**RE: Murphy Express – Unser Blvd
221 Unser Blvd. SW
Grading and Drainage Plan
Engineer's Stamp Date: 03/20/20
Hydrology File: K10D061**

Re: Murphy Express – Unser Blvd
Grading and Drainage Plan
Hydrology File: K10D061
PAE Job No. 11298

GRADING PLAN
MURPHY EXPRESS
221 UNSER BOULEVARD SW
ALBUQUERQUE
NEW MEXICO

C-3

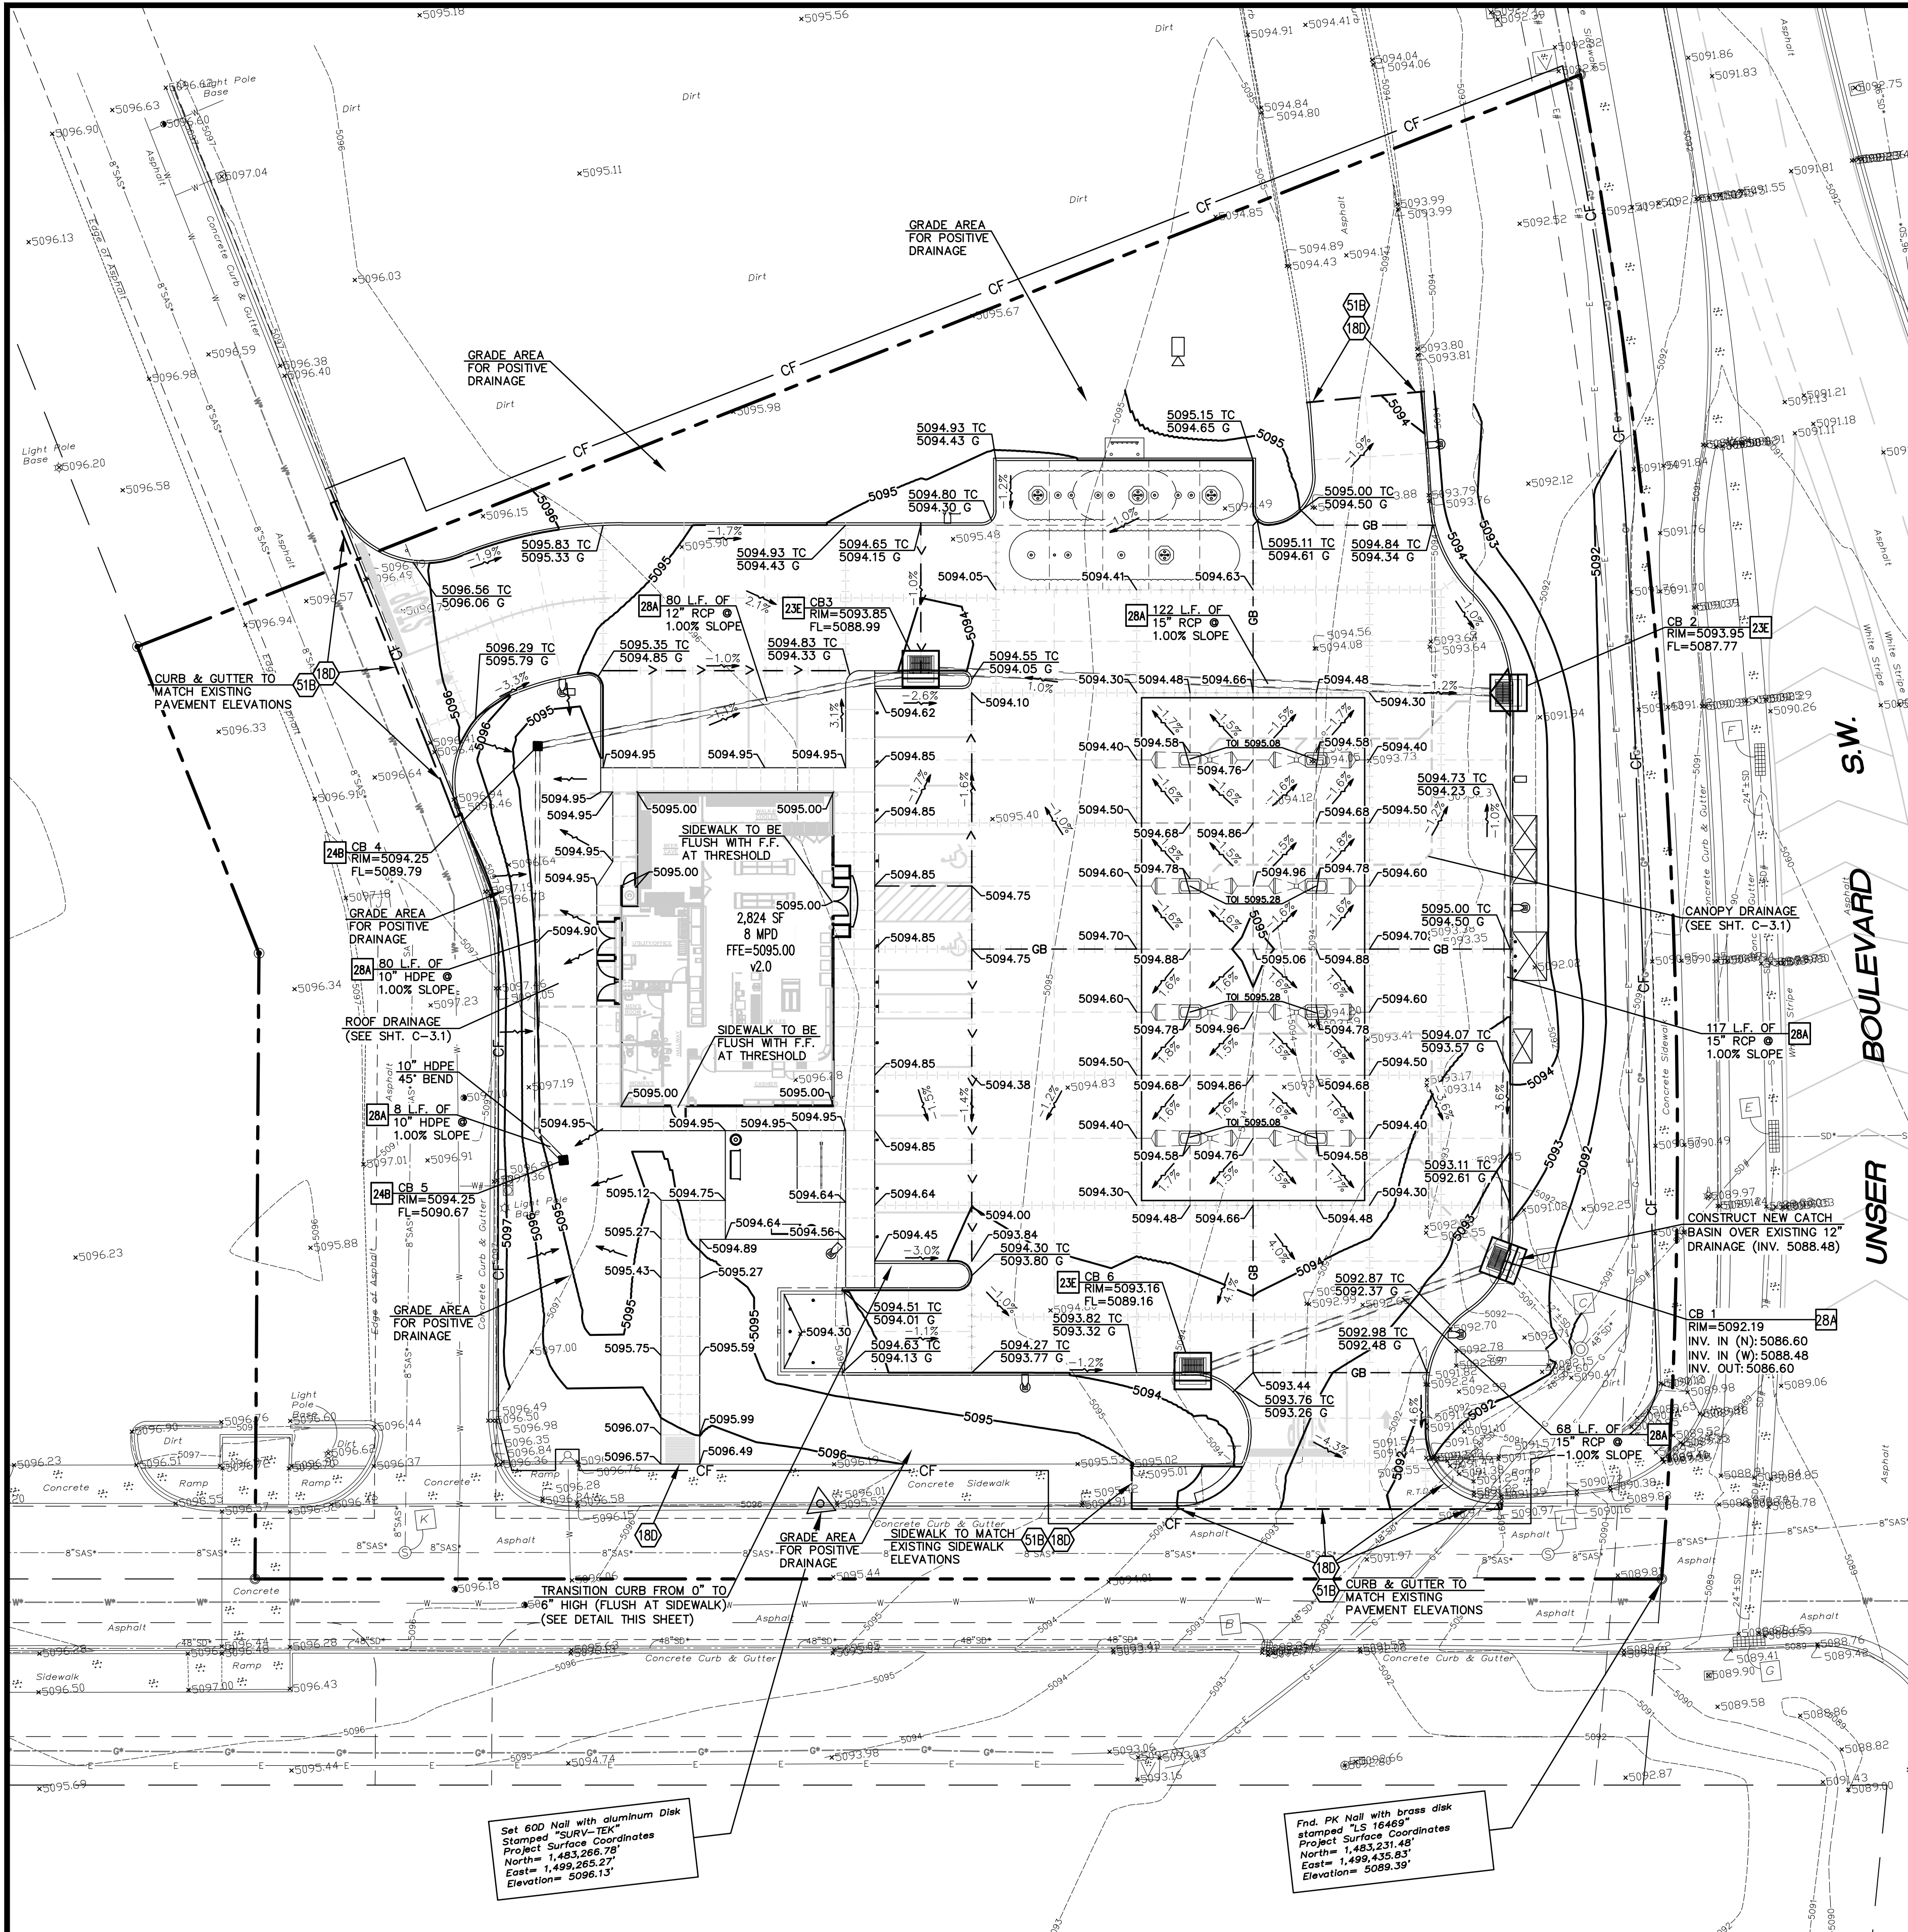
1. Comment: Please provide all missing information from the Grading Plan Checklist (c, e, & f) Per the DPM Chapter 22 Section 7 – Grading Plan Checklist, the following must be on the Grading Plan. Please add an Engineer's Stamp Date.

- a. Comment: Please provide an engineer's stamp with a signature and date.

- c. Comment: Please provide a Vicinity Map.

- e. Comment: Please provide the FIRM Map and flood plain note with effective date.

- f. Comment: Please provide a legal Description of the property.

2. Comment: It appears that your engineering stamp is incorrect. The NM Board of Licensure for Professional Engineers and Professional Surveyors Administrative Code 16.39.3.12.C. states, "The design of the seal/stamp shall consist of three (3) concentric circles, the outermost circle being one (1) and one-half (1/2) inches in diameter..."

3. Comment: Please label Unser Blvd.

5. Comment: Please add a statement that this site is part of the User Crossing Master Drainage Plan by BHI dated 10/30/08.

8. Comment: Please remove all the smaller increment contour lines. It will make the G&D more readable. One foot contours is fine and since you have spot elevations.

9. Comment: Along both the East & West of the site, it appears that the grades are greater than 3:1 side slope. Please verify that is fine. If they are greater than 3: 1, than a retaining wall may be needed.

Response: See revised Sheet C-3, Grading Plan with corrected stamp.

Response: See revised Sheet C-3, Grading Plan with vicinity map.

Response: See revised Sheet C-3, Grading Plan with flood zone determination info.

Response: See revised Sheet C-3, Grading Plan with legal description.

Response: See revised Sheet C-3, Grading Plan with corrected stamp.

Response: See revised Sheet C-3, Grading Plan with Unser Blvd. labeled.

Response: See revised Sheet C-3, Grading Plan with requested statement.

Response: See revised Sheet C-3, Grading Plan with revised contours as requested.

Response: See revised Sheet C-3, Grading Plan with revised grading in rear of building. Maximum slope has been revised to not exceed 3:1.
